**Mercury Cluster Solar PV Project:
Kleinfontein Solar PV1 (120MW)
(on Portion 1 of the Farm Kleinfontein No 369, Free State Province)**

Comments & Responses Report

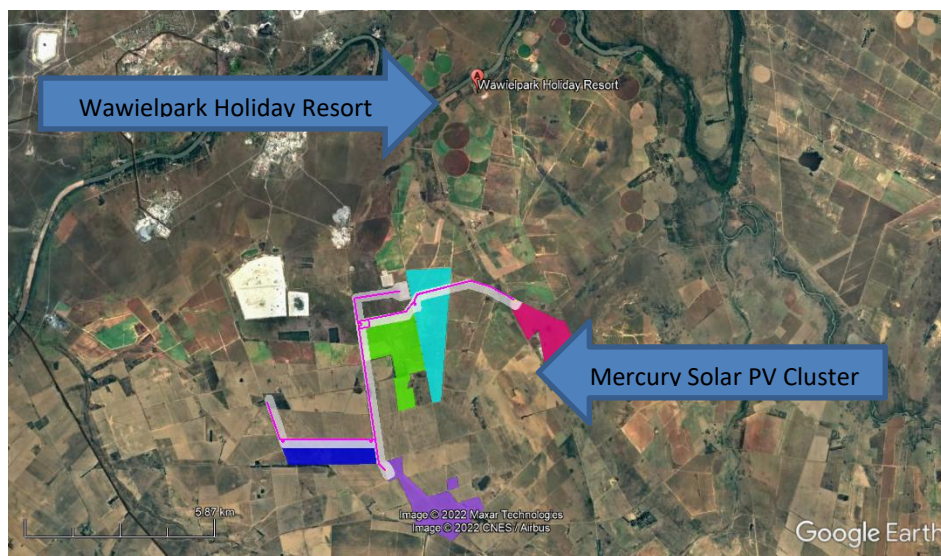
1. Mr Botha requested to be registered as an IAP
2. The kml files of the proposed development was requested
3. Mr Botha phoned Landscape Dynamics and explained that a special procedure needs to be followed when power lines crosses land belonging to a mine.

1. Mr Botha and the Harmony mine is a registered IAP.
2. The requested KMZ files were emailed to Mr Botha
3. It is Landscape Dynamics' understanding that the following two properties may be affected (the white blocks on the map below):
 - a. Remainder of the Farm, Moab, No 279
 - b. The Farm Zaaiplaats, Portion 2, No 190
